CITY OF TUCKER

ITB #2026-001

ROSENFELD PARK IMPROVEMENTS CONSTRUCTION

ITB #2026-001
ADDENDUM #1

Rosenfeld Restroom

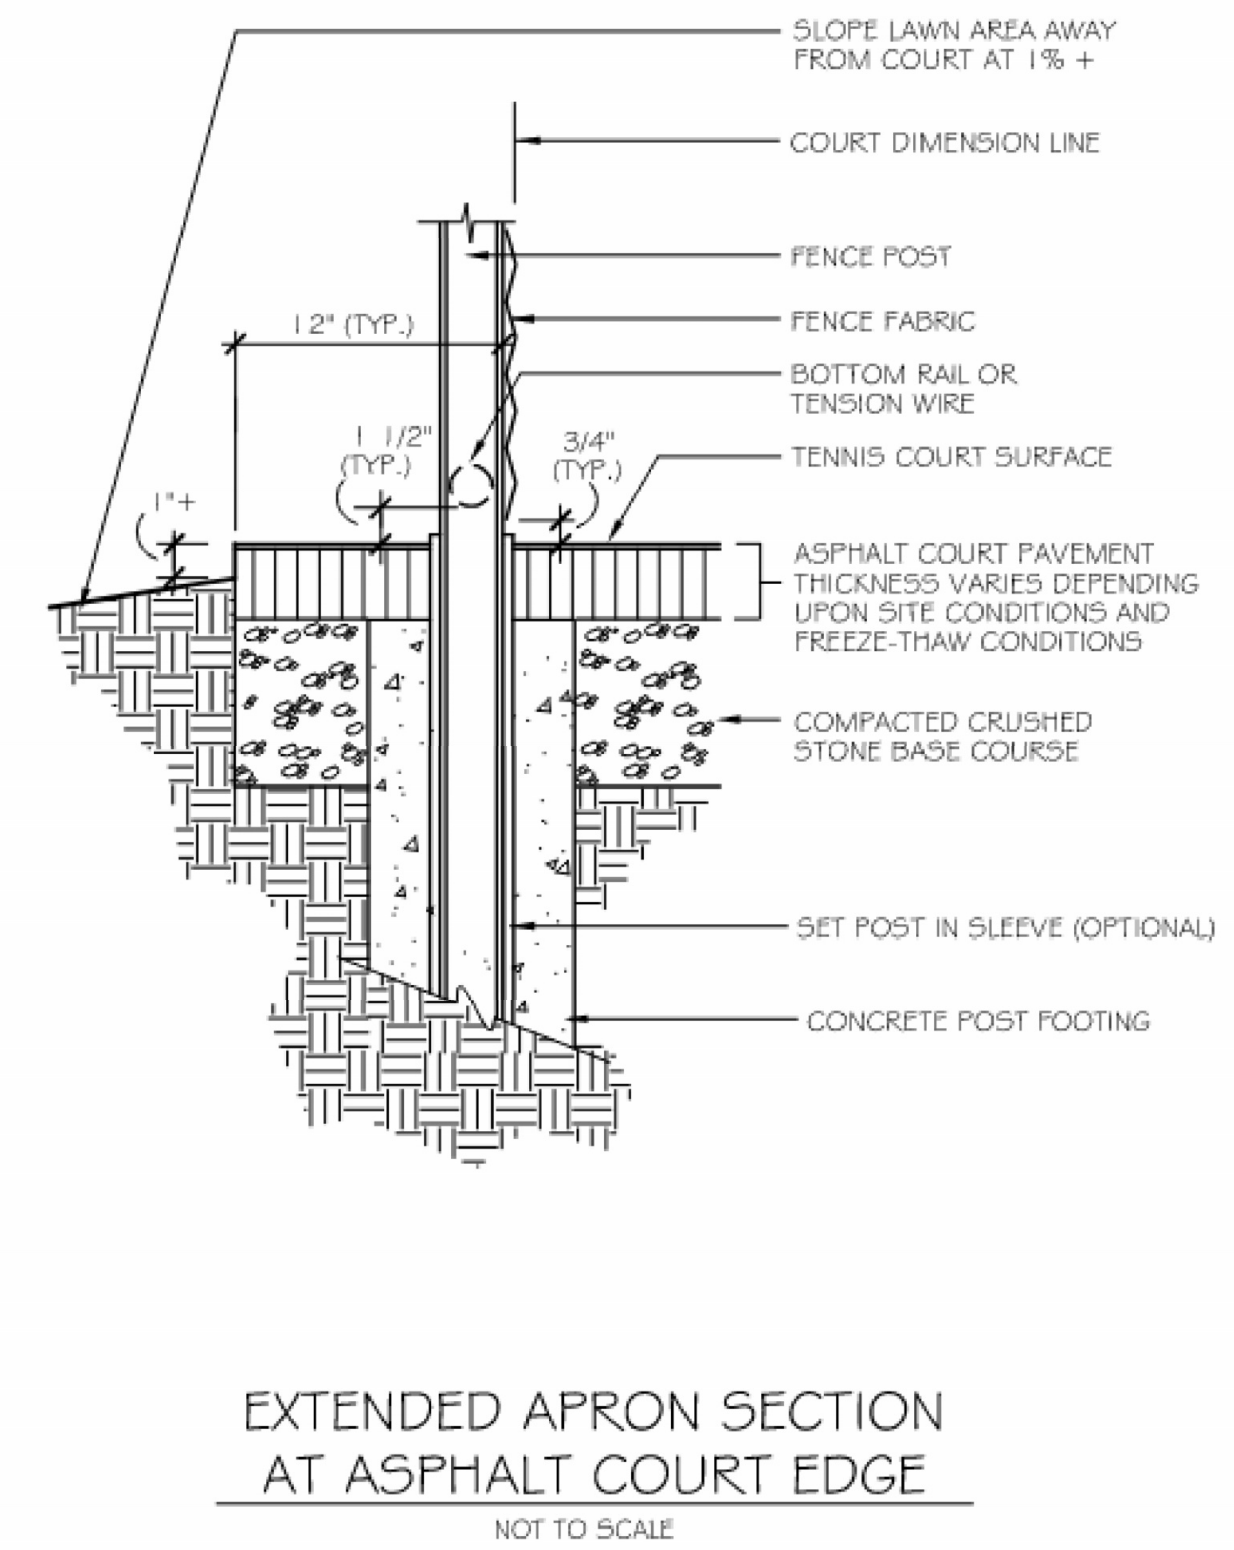
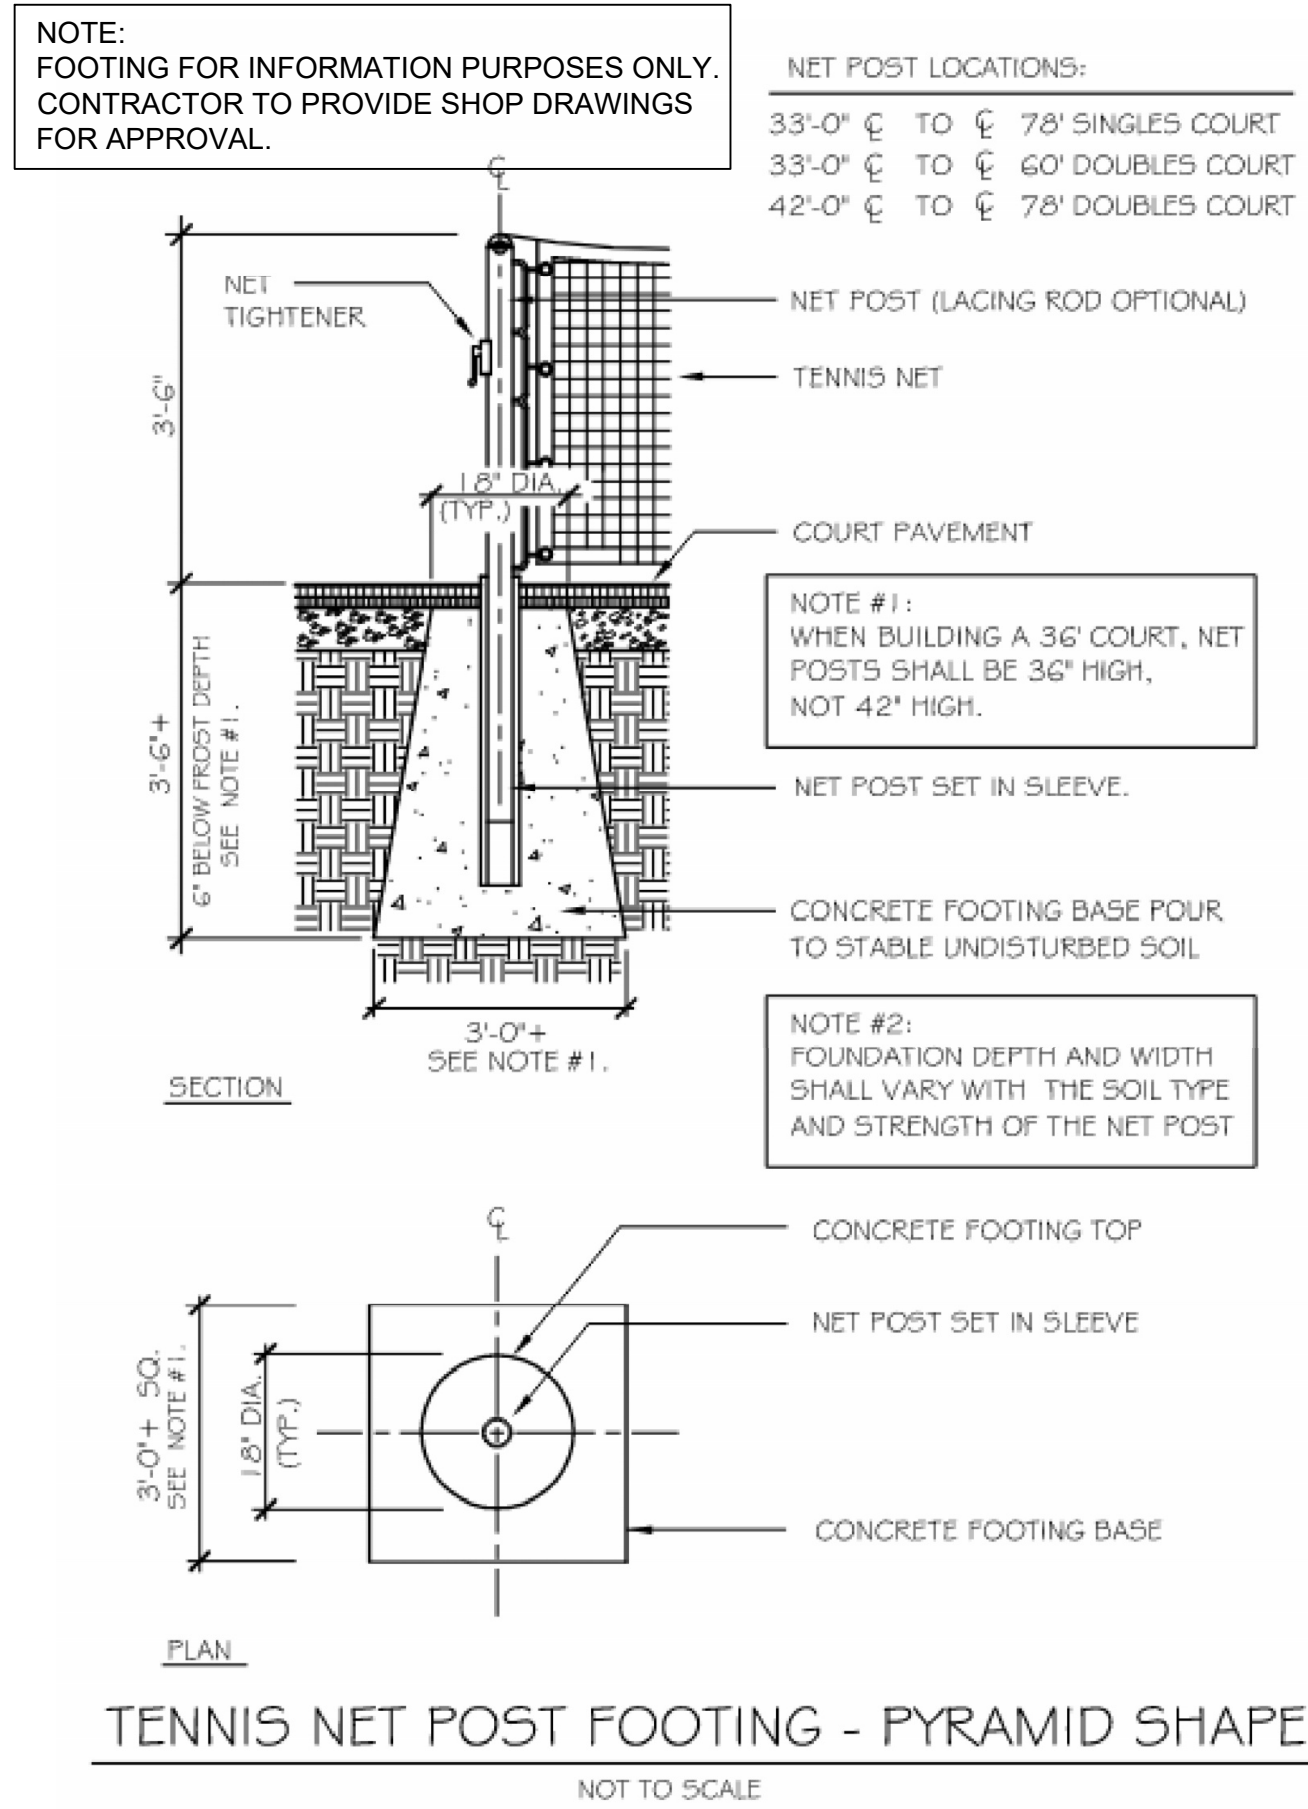
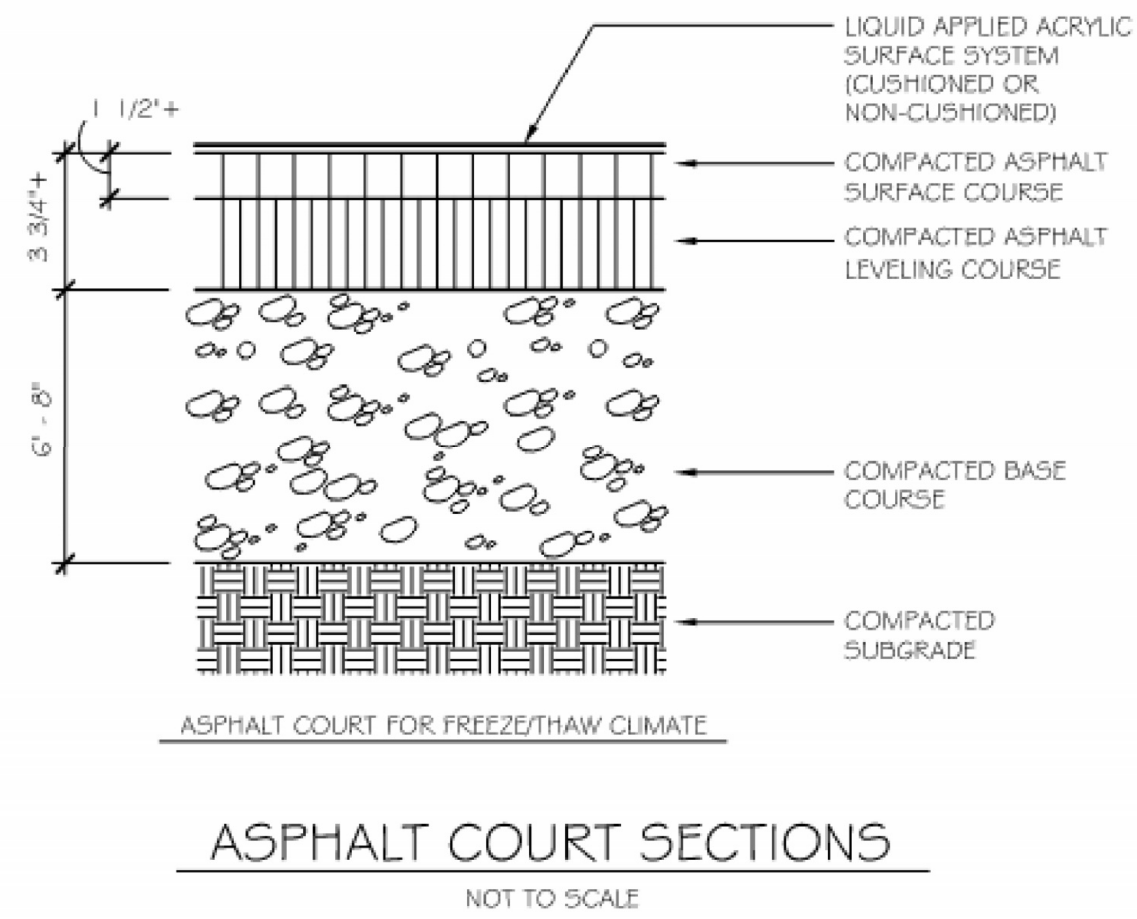
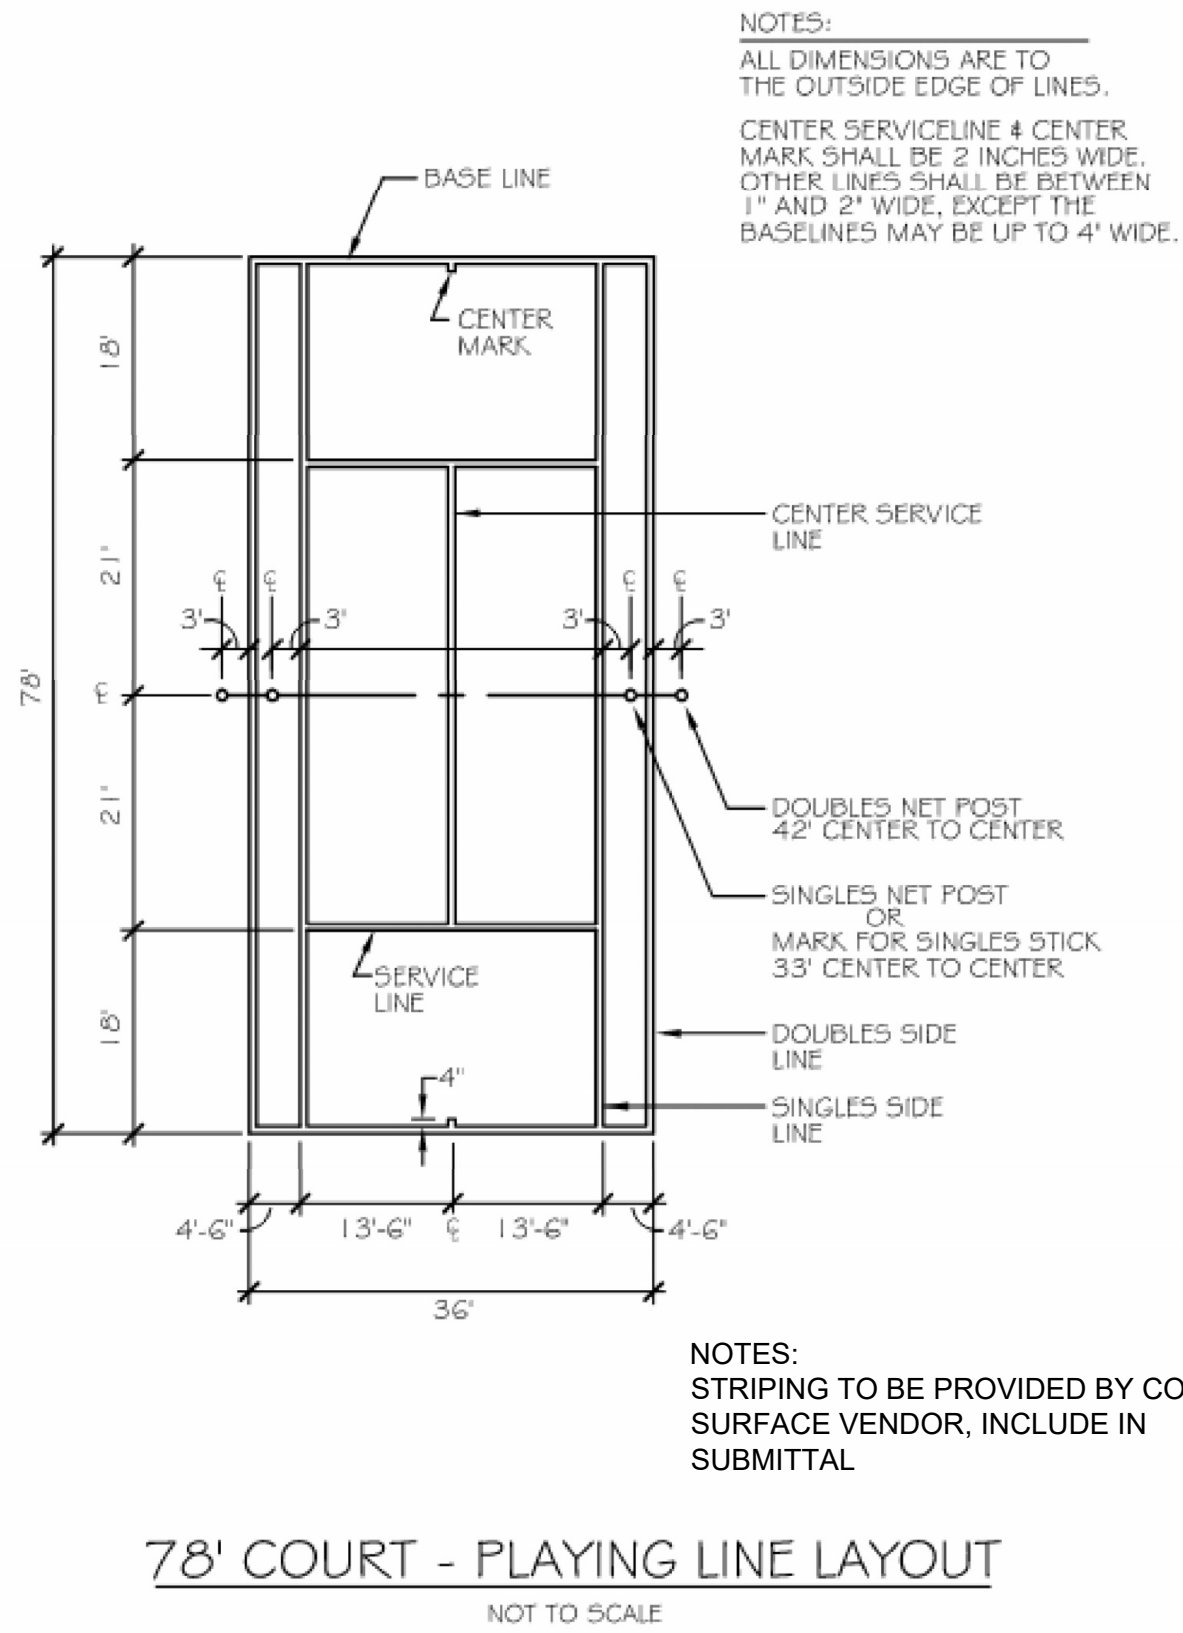
| | QUESTION | ANSWER |
|----|--|---|
| 2 | Where is the septic system located? | Refer to provided sheet in this addendum for photographic estimate of location. |

| 34 | Is the existing restroom connected to a septic system or public sewer? If septic, are the septic tank and drain field considered potential conflicts with the proposed work? | Yes. There is a septic tank. Refer to provided sheet in this addendum for photographic estimate of location. |

Approximate location of restroom building

Approximate location of septic tank (behind restroom building)

5 **COURT SURFACE SYSTEMS**

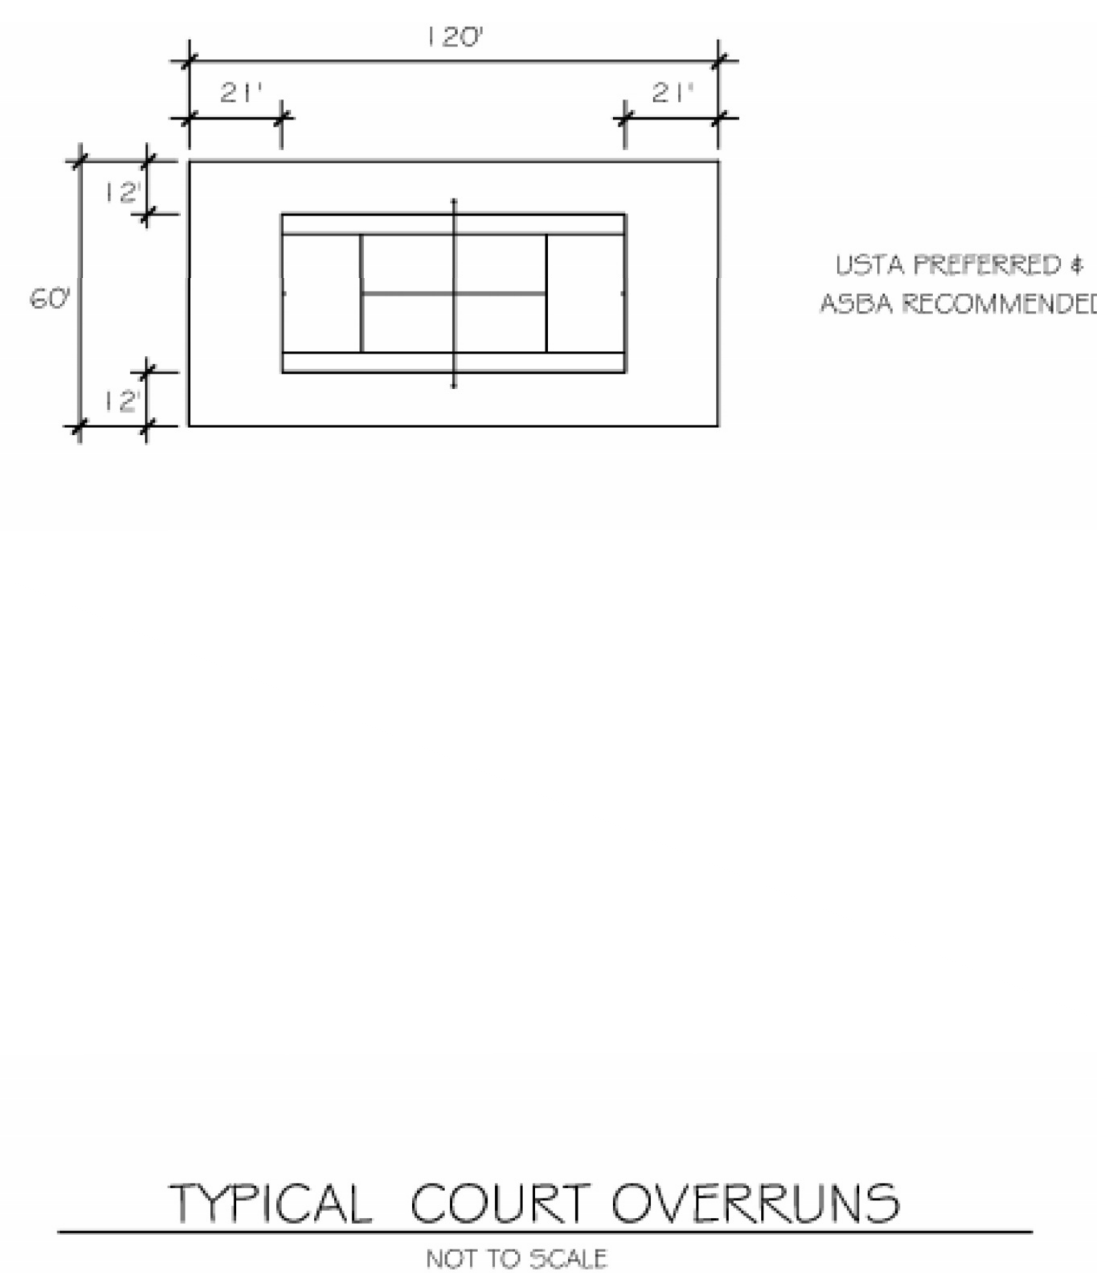
| | QUESTION | ANSWER |
|----|--|---|
| 7 | Nova products specified for the surfacing. Is the city open to using Acrytech or California Sports Surfaces: https://atsports.com/acrytechsportscoatings/ https://www.californiasportssurfaces.com/ | The detail has been modified to include acrylic surfaces. Please refer to revisions found on D.01. |
